TOWN OF CHAPIN
Architectural Review Board
Regular Meeting
Council Chambers, Chapin Town Hall
August 6, 2025
6:00 PM

To: Architectural Review Board
From: R. Radtke, Planning & Zoning Manager
Date: July 16, 2025
Re: Outparcel 3– Medical Office

To: Architectural Review Board
From: R. Radtke, Planning & Zoning Manager
Date: July 23, 2025
Re: Carolina Wings – Commercial Sub-division

To: Architectural Review Board
From: R. Radtke, Planning & Zoning Manager
Date: July 17, 2025
Re: Express Oil – Commercial Sub-division

1 03 Exterior Elevation, Right (East)
1/4" = 1'-0"

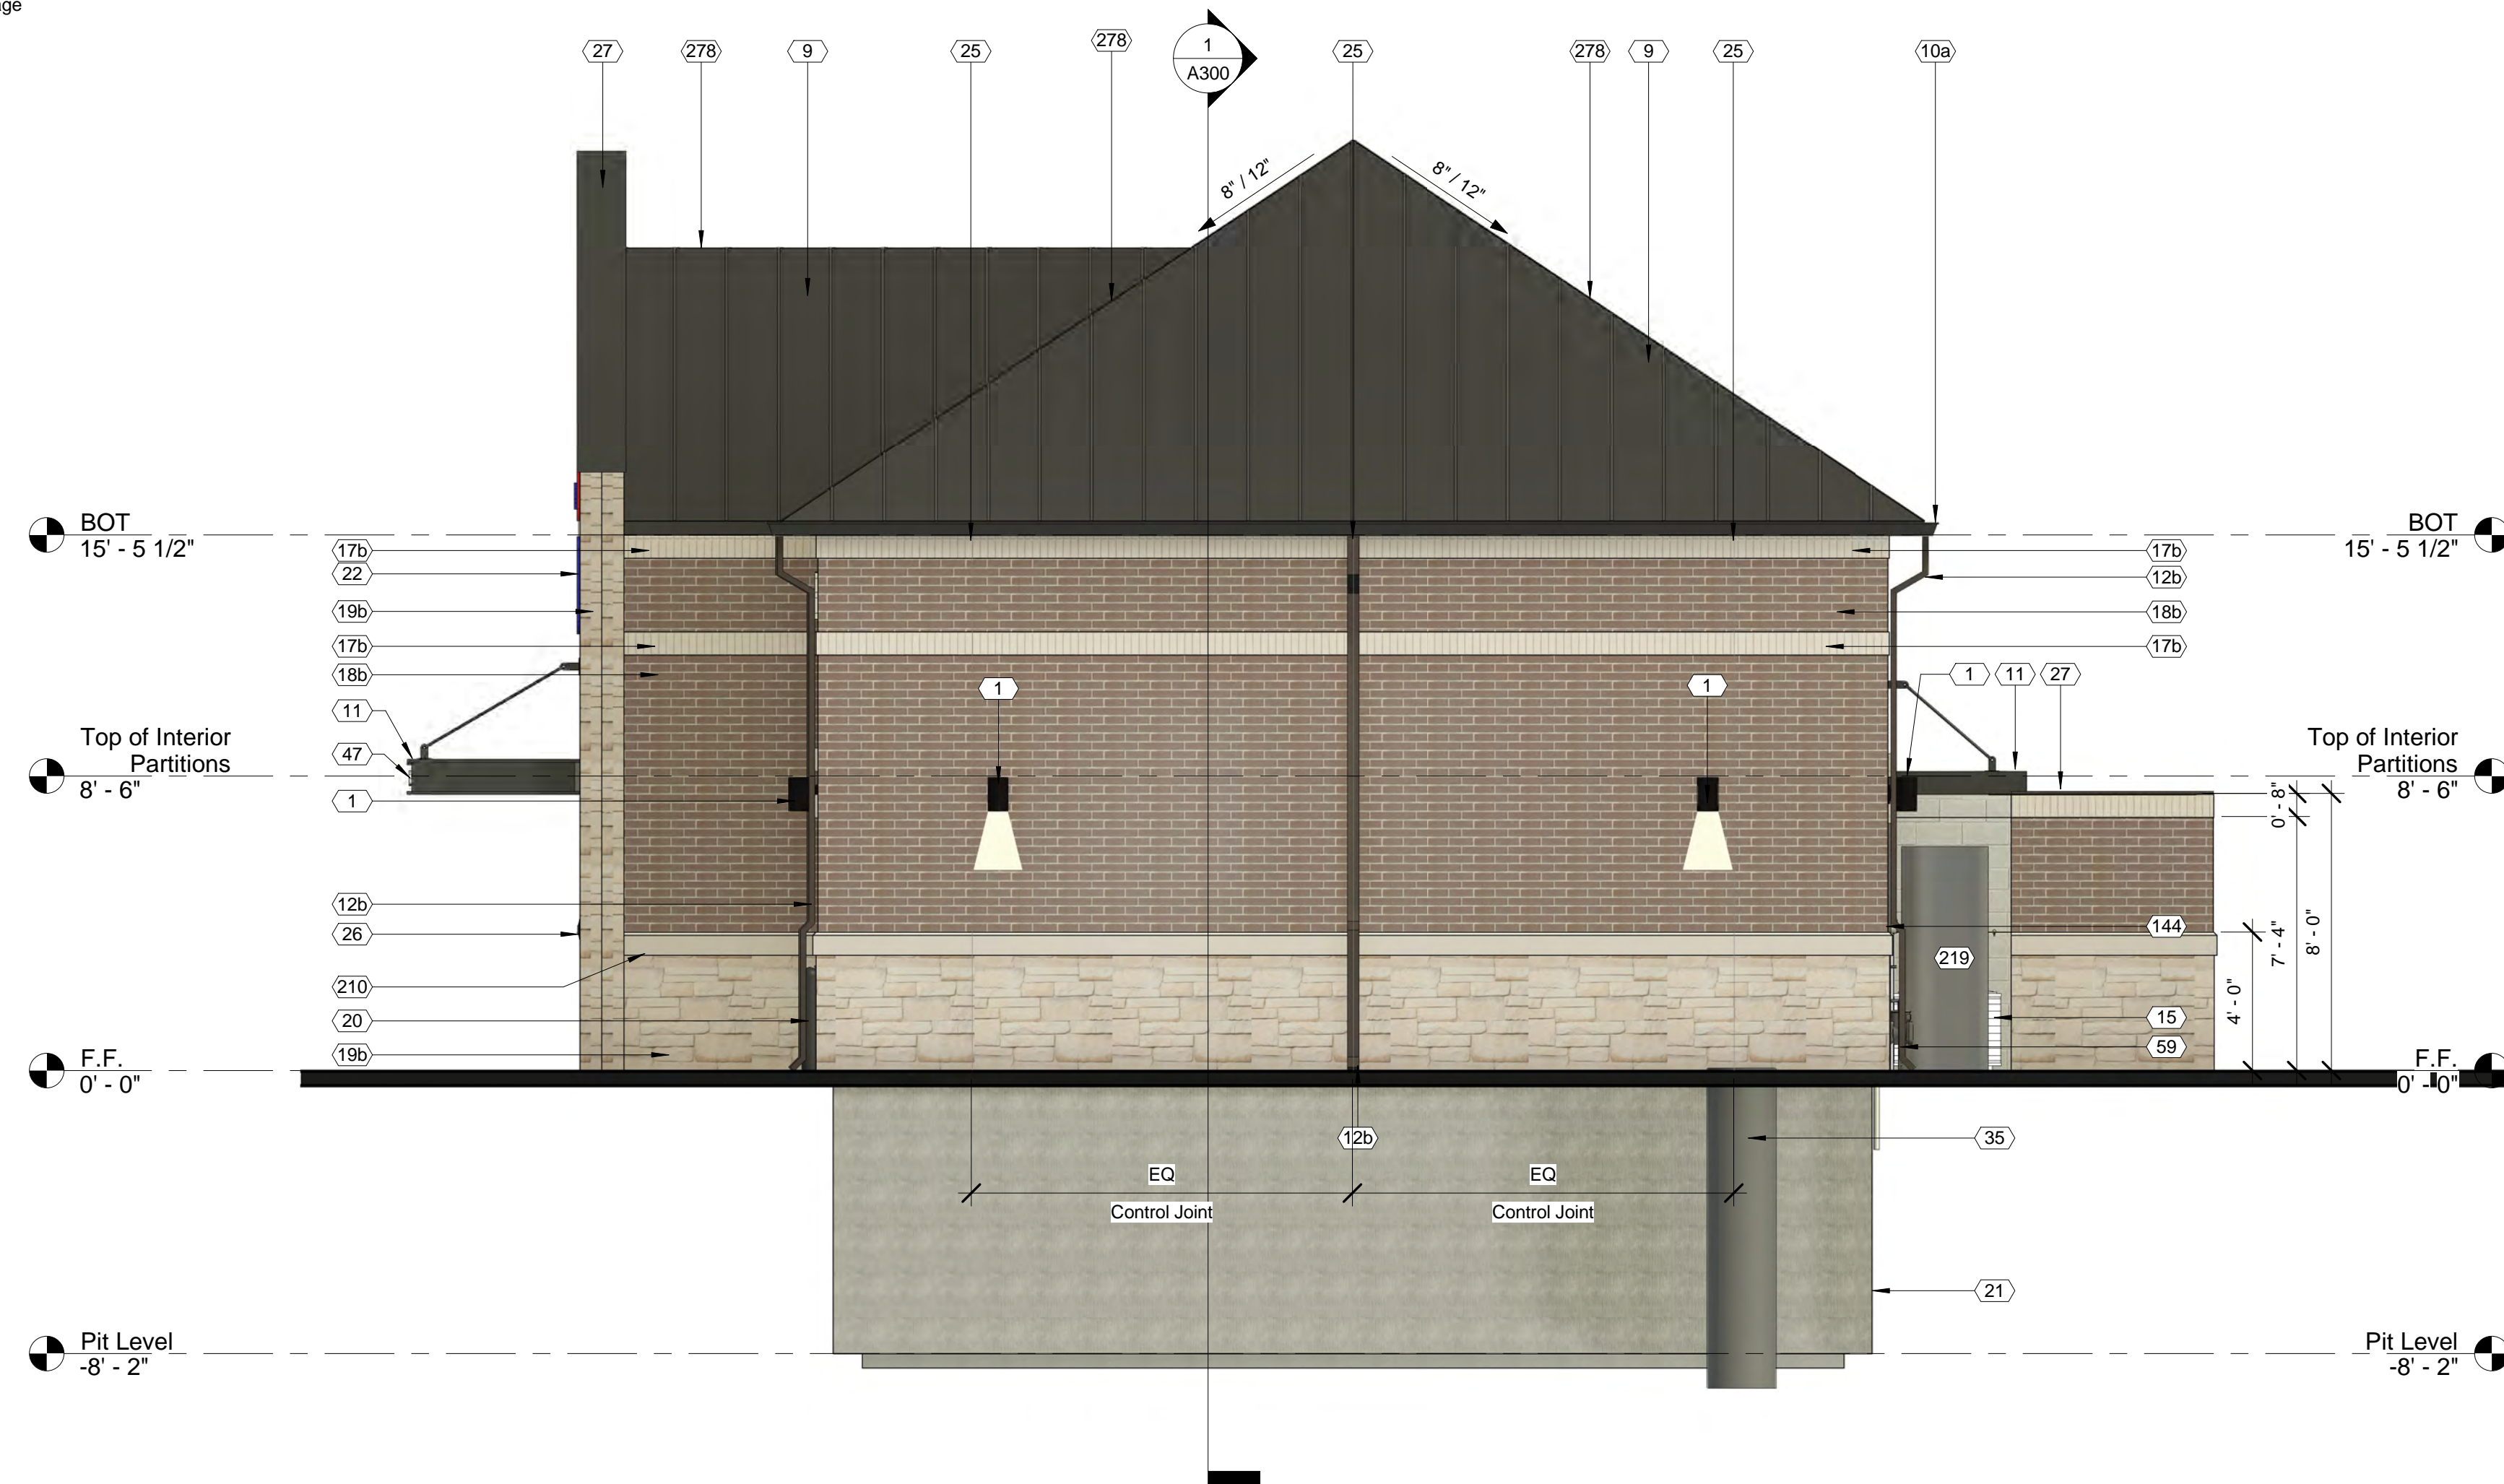
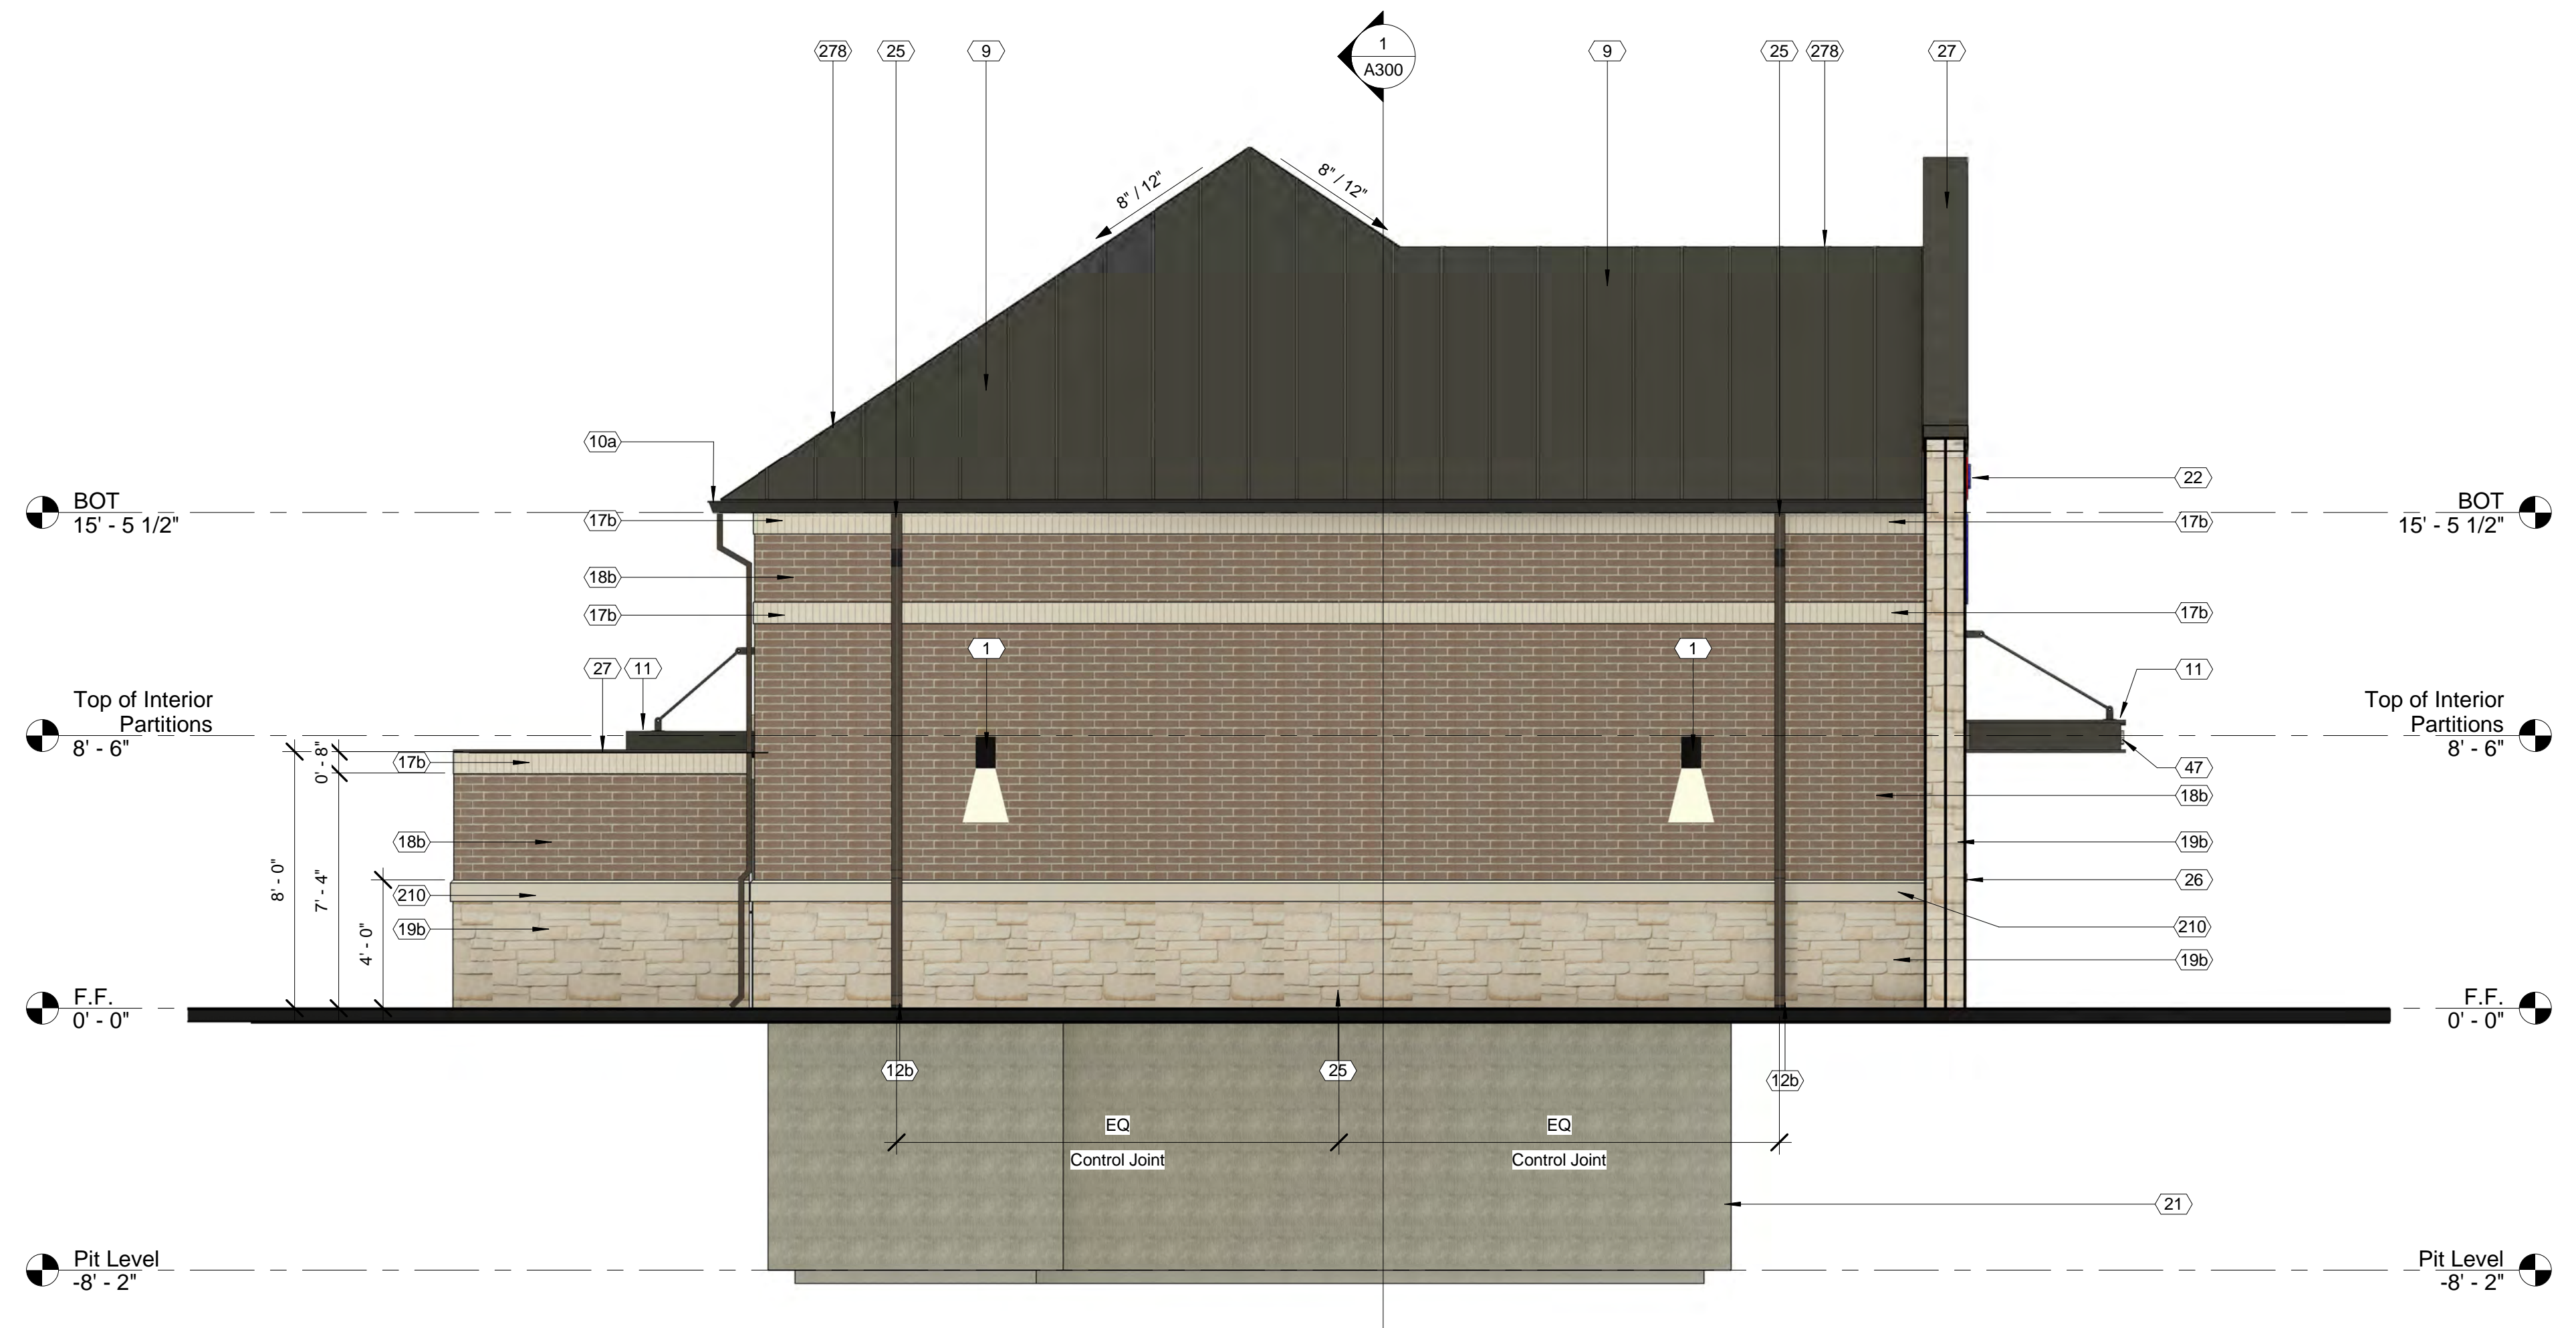
- Exterior color of building that are shown are not on the approved color pallet list. Brick colors - Dark Sandstone, Stone color - Sedona, Overhead doors - White **6.12.3.C.3.** [Approved-Color-Palette](#)
- Windows building does not meet the building frontage requirement of 30% glazing. **6.12.3.C.a**
- Parking appears to be short of the minimum required. **(Table 8.4.1)**
- Does not appear to be any landscape island dimensions. **(7.4.2.)**
- Details and locations needed for open space to be shown on plan. **(5.4.1).**
- Plan does not show any pedestrian interconnectivity as required – **8.6.3**
- No Screening of the exterior ladder or down spouts. **6.12.7.b.**
- Clarification on wall materials to building that are used for screening dumpster **6.12.7.a.**
- Confirm location of mechanical units and screening. **6.12.7.d**
